II. Markup of Proposed Change

REACTOR CORE SAFETY LIMIT - FOUR LOOPS IN OPERATION

IV. Safety Evaluation of License Amendment Request 93-03 Proposed Change

FIGURE 2.1-1

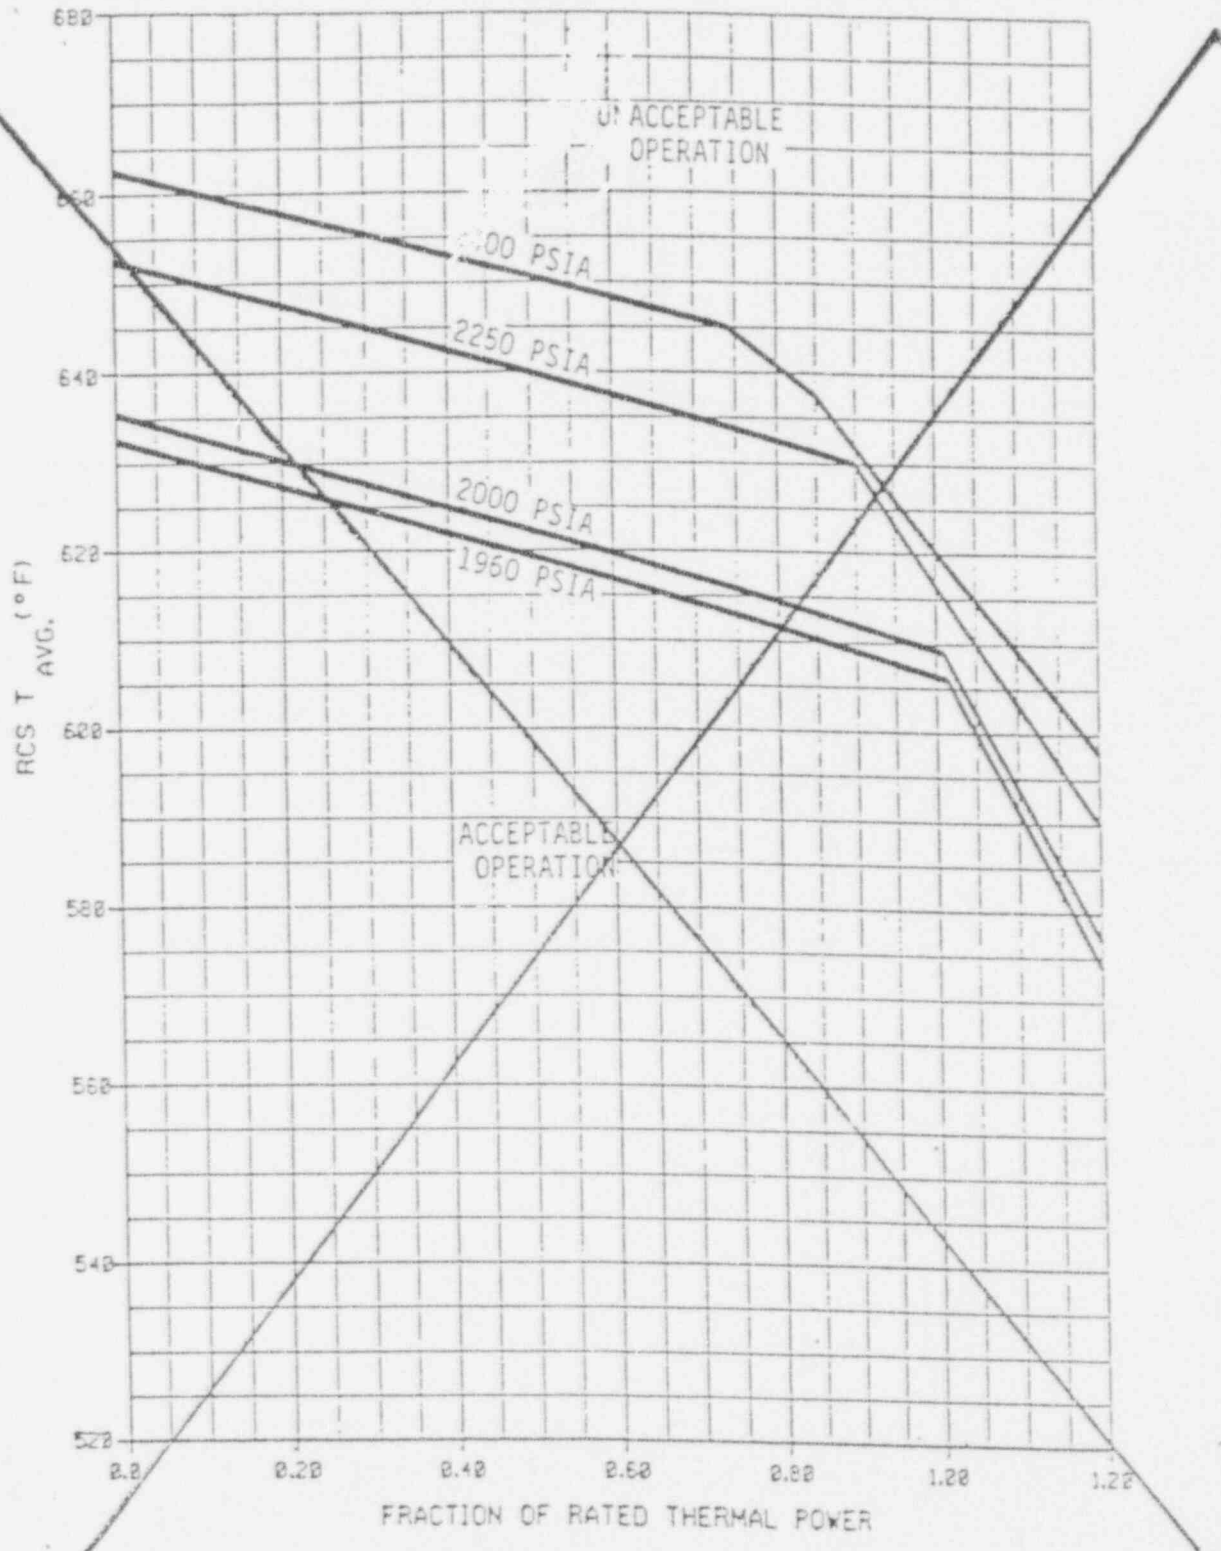
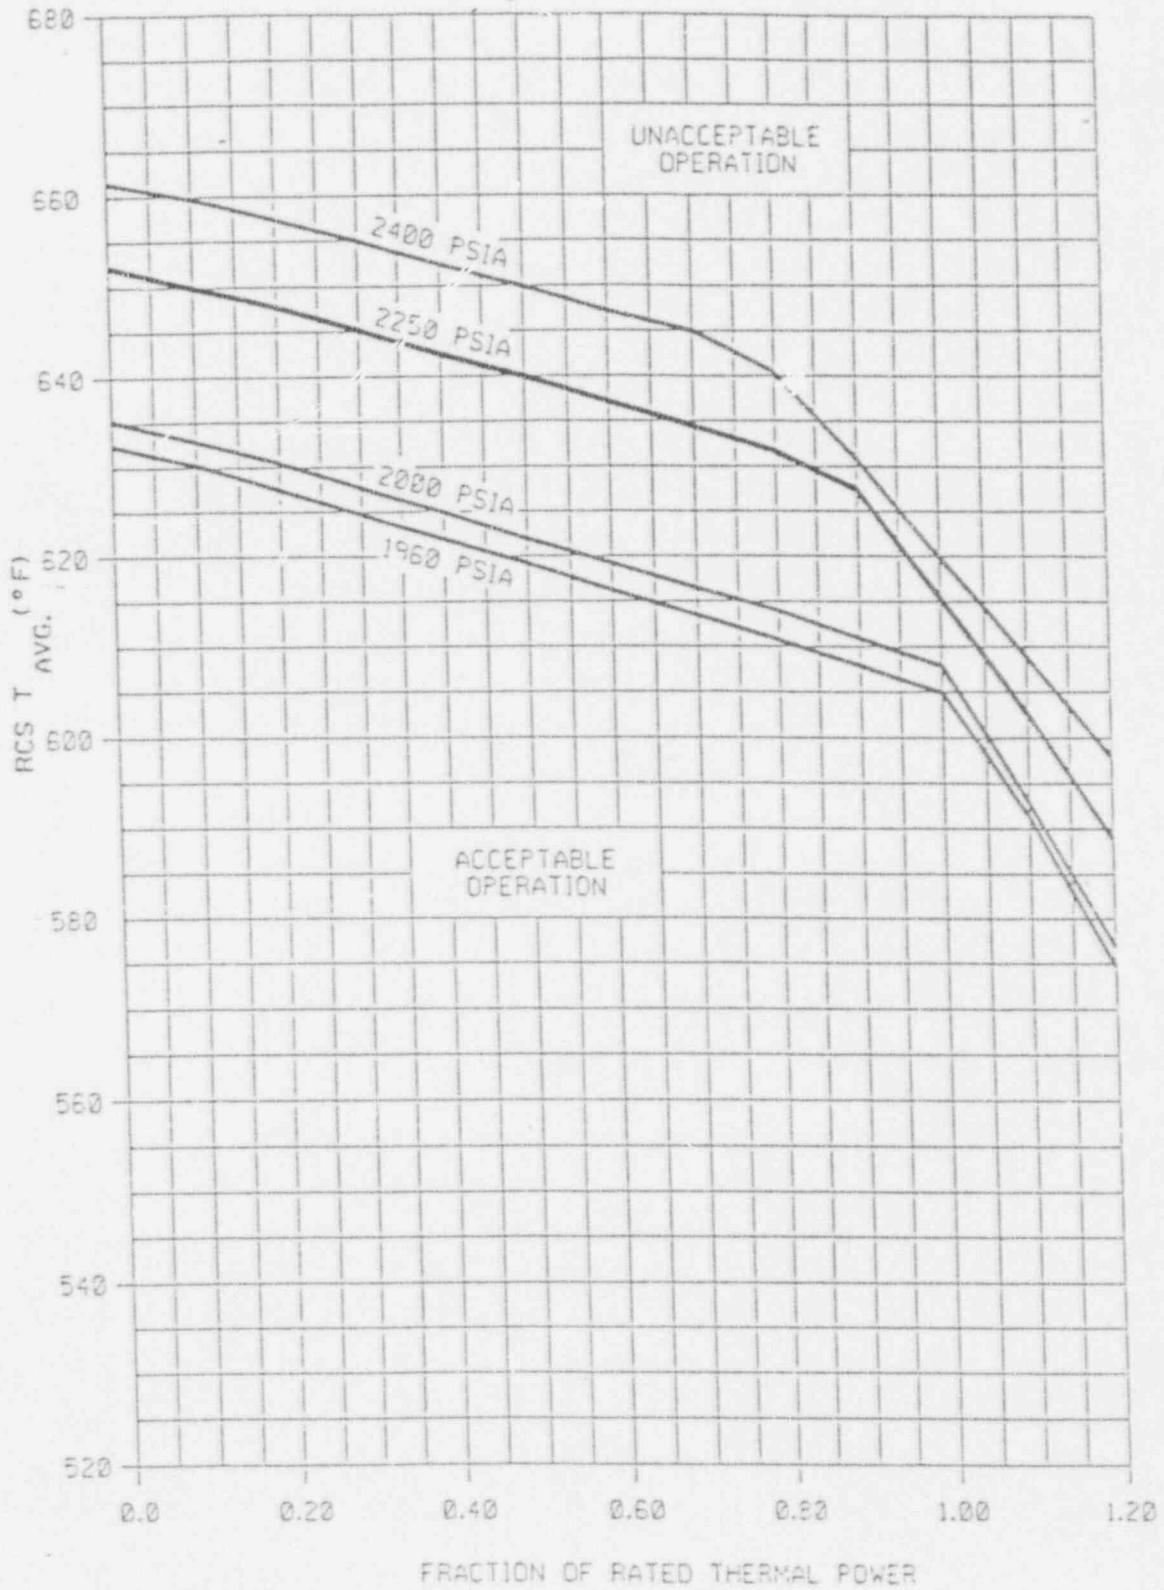
See attached markup of proposed changes to Technical Specifications.

Seabrook Station Licensee Event Report (LER) 92-02-01 reported that the curves of Technical Specification Figure 2.1-1, Reactor Core Safety Limit - Four Loops in Operation, were non-conservative. The non-conservative curves were identified as a result of a North Atlantic review of the Technical Specification values provided to North Atlantic by Westinghouse. It was determined, through a comparison of Westinghouse design documents to the actual curves in Figure 2.1-1, that the curves in the region of 80% to 110% of rated thermal power (RTP) do not accurately represent the loci of points upon which the curves are based. For example, the 1960 psia curve at 100% of RTP should provide a value of 605.0°F, while the actual curve in Figure 2.1-1 is closer to 606.5°F. There are other points in this region that can be determined to be non-conservative when compared to the loci of points.

This condition was reported to the NRC in Licensee Event Report 92-02-01. One of the corrective actions specified in LER 92-02-01 was to revise Technical Specification Figure 2.1-1 to include curves which accurately reflect the loci of points upon which they are based. This submittal addresses that corrective action.

INSERT 2

FIGURE 2.1-1

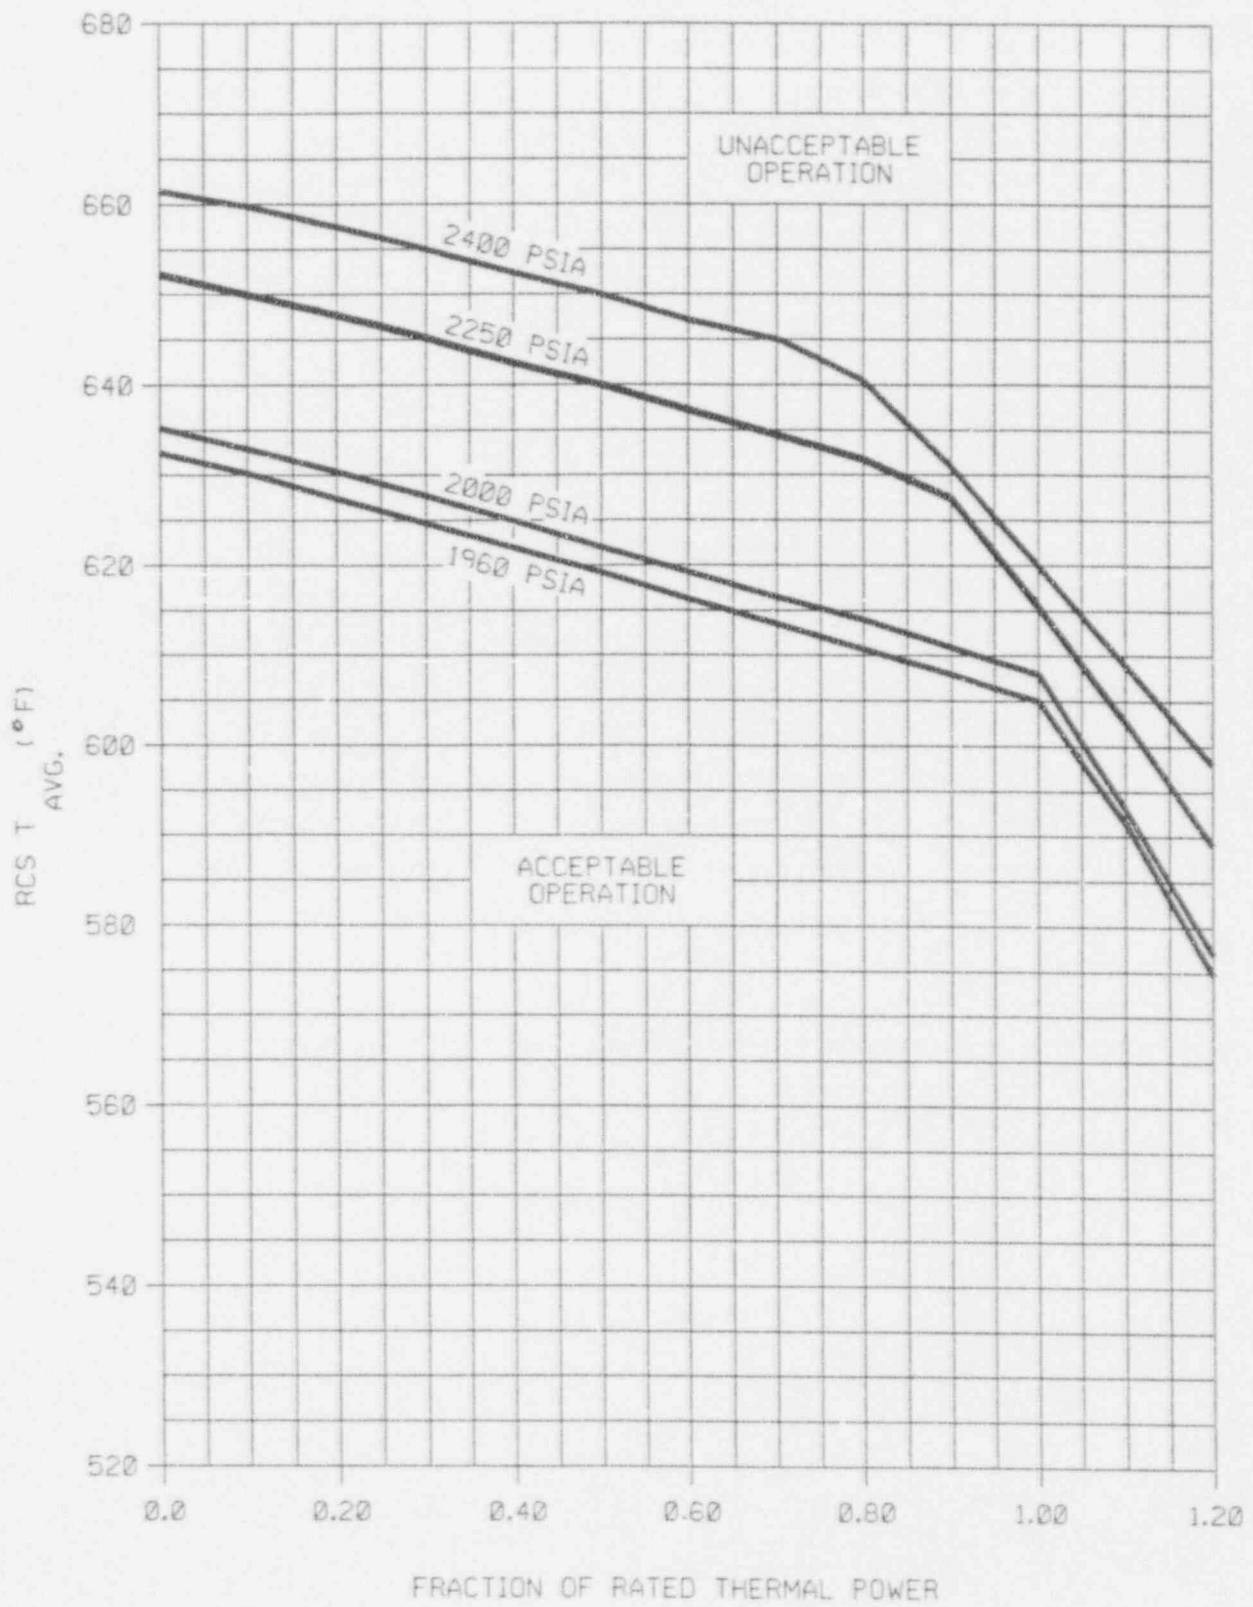
See attached retype of proposed changes to Technical Specifications. The attached retype reflects the currently issued version of Technical Specifications. Pending Technical Specification changes or Technical Specification changes issued subsequent to this submittal are not reflected in the enclosed retype. The enclosed retype should be checked for continuity with Technical Specifications prior to issuance.

The revision to the curves to accurately reflect the loci of points upon which the curves are based will ensure that if the Reactor Protection System trip functions, as discussed above, are exceeded the evaluations made to verify if a safety limit has been exceeded will be accurate. A review of the Seabrook Station Technical Specifications Bases and Updated Final Safety Analysis Report Sections 4 and 15 verifies that the proposed change does not alter the design, function or operation of the plant. This proposed change does not affect any existing accident analyses, and it does not introduce the possibility of any accidents or malfunctions not already analyzed. Since the proposed change is providing the more conservative values for Figure 2.1-1 to reflect the design basis it does not reduce the margin of safety as defined in the bases of the Technical Specifications and preserves the margin originally established. The revision to the curves will not affect any methods of operating. This revision ensures that the design basis and the safety limits are accurately and appropriately reflected in the Technical Specifications and will ensure

The correction of the curves in Figure 2.1-1 does not decrease the margin of safety as described in the Bases of the Technical Specifications, but rather ensures that the margin of safety as presented in the Bases and established by the design basis is maintained.

The loci of points used to generate the revised curves for Technical Specification Figure 2.1-1, Reactor Core Safety Limit - Four Loops in Operation, is enclosed.
